Bulletin No. 2002-07

RF Interference Between MotorGuide Excel Sonar-Ready Motors and Pinpoint Sonar Displays

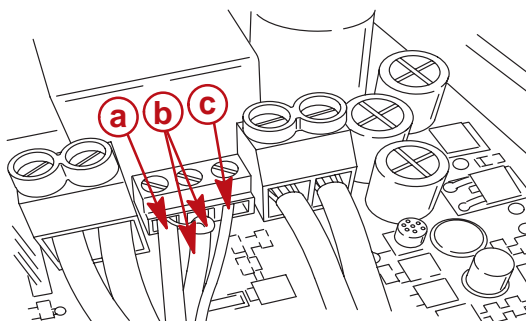
Under certain circumstances, RF interference may occur between the MotorGuide Excel motor and the Pinpoint sonar display.

Should you encounter RF interference between the Excel motor and the Pinpoint sonar display, inspect the 24 AWG (0.8 mm²) white ground wire coming from the transducer to the TB3 green terminal block on the circuit board. There should be one 24 AWG (0.8 mm²) white transducer ground wire on terminal C, an 18 AWG white return ground wire on terminal B and an 18 AWG blue pulse-width modulation (PWM) wire connected to terminal A. Also inspect for the presence of the blue .22 uf 50v capacitor connected to terminal B with the white return ground wire and to terminal A with the blue PWM gate lead. The 24 AWG (0.8 mm²) white transducer ground wire must be connected to terminal C and the capacitor must be present. If the capacitor is damaged or missing it must be replaced. If the ground wire is missing, replace the magnet housing.

- a** - 18 AWG PWM wire
- b** - 18 AWG return ground wire with .22 uf 50v capacitor
- c** - 24 AWG transducer ground wire
